Rickmansworth Aquadrome NLHF Project

Public Engagement Session

Wednesday 16 September 2026

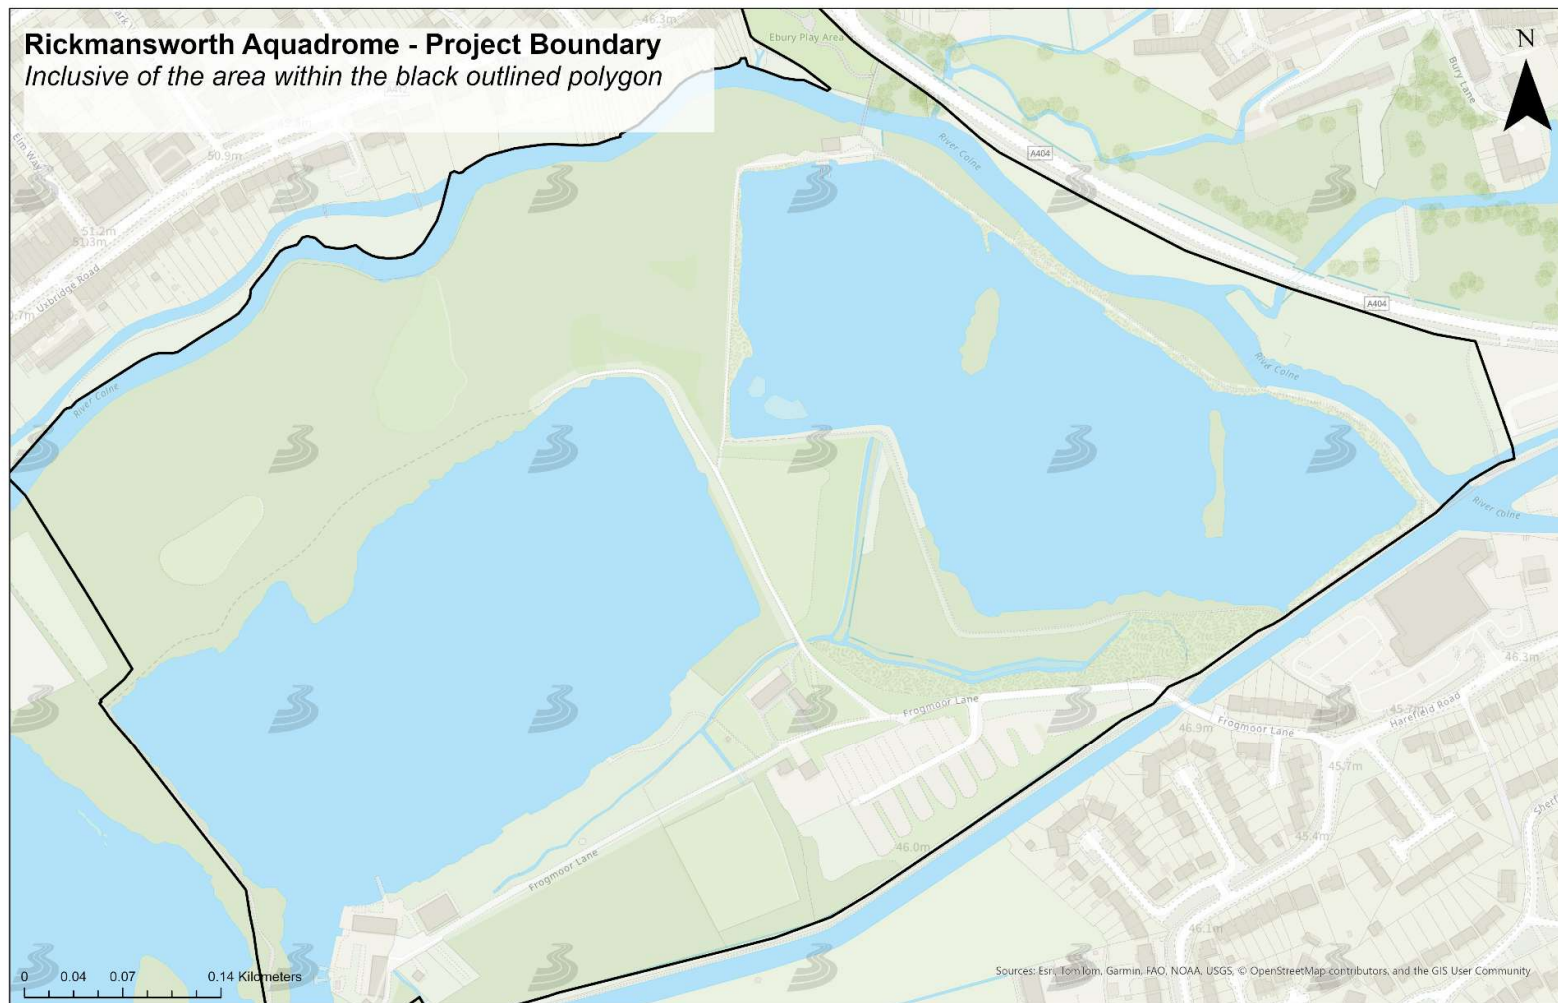
- 1. At the Climate Change and Leisure Committee Meeting held on 24th June 2026, an officer stated. ‘...*that within the Aquadrome boundary there is an increase to flood risk, however, this benefits the flood plain of the Aquadrome. Outside of the boundary, there is no increase to flood risk*’. The questions arising from this definitive statement – reflected in the Committee minutes are;**
- a. What is the defined boundary to the Aquadrome being used as the scope for this statement. Please provide a detailed map.**

Rickmansworth Aquadrome - flood modelling (basic)

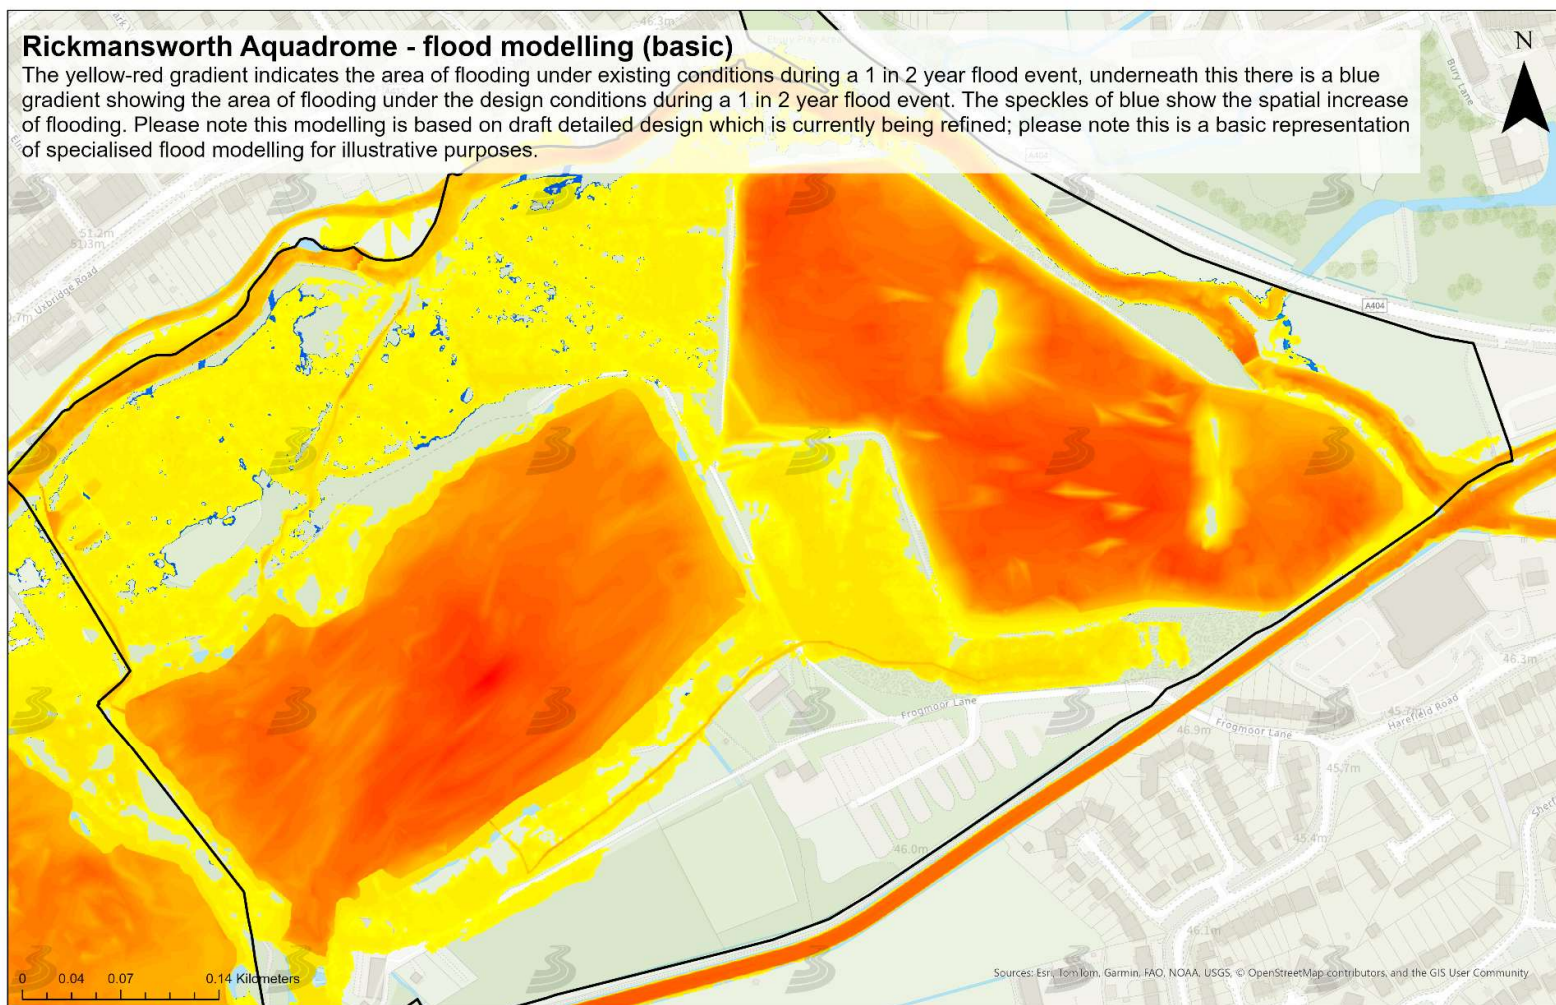
- b. How far outside of the boundary of the Aquadrome will there be no increase to flood risk. Please provide a detailed map of where there is no increase to flood risk as a consequence of the TRDC plans. (what is the exact scope for this definitive statement?)**

c. Please provide all tangible evidence for making the statement ‘*Outside of the boundary, there is no increase to flood risk*’

The yellow-red gradient indicates the area of flooding under existing conditions during a 1 in 2 year flood event, underneath this there is a blue gradient showing the area of flooding under the design conditions during a 1 in 2 year flood event. The speckles of blue show the spatial increase of flooding. Please note this modelling is based on draft detailed design which is currently being refined; please note this is a basic representation of specialised flood modelling for illustrative purposes.

The draft designs for river restoration have been subjected to significant flood modelling with further technical work ongoing. The Aquadrome has been placed within the context of the catchment (through utilisation of the updated EA model) and also to within the Colne Valley down to at least Maple Lodge Sewage Treatment works. The modelling is run based on the existing conditions and then the proposed improvements are “installed” into the site, and the model is run again to show the design output. The difference is then analysed to show if there is any change to flood risk. This information is then evaluated by the EA when a flood risk activity permit application is submitted, if there is an increase to flood risk within the design the FRAP would not be granted; the EA would not permit the scheme if there was an increase to flood risk.

“The results of the hydraulic modelling show a small increase in flood depths (up to 200 mm) in the woodland north of Bury Lake, in the swale between Batchworth and Bury Lakes, and in the new fish pass channel (within the Aquadrome). The results do not indicate any changes in flood extents outside of these design areas (this includes the Aquadrome project boundary).

There is no change to pass forward flows at the downstream extent of the model, which indicates there won’t be a change in flood risk downstream of the modelled extents. (the modelled extents are to approximately Maple Lodge Sewage Treatment works).

The modelling does not indicate any flood receptors are adversely affected by the proposed design and suggests there is no substantive change to flood risk in the area.”
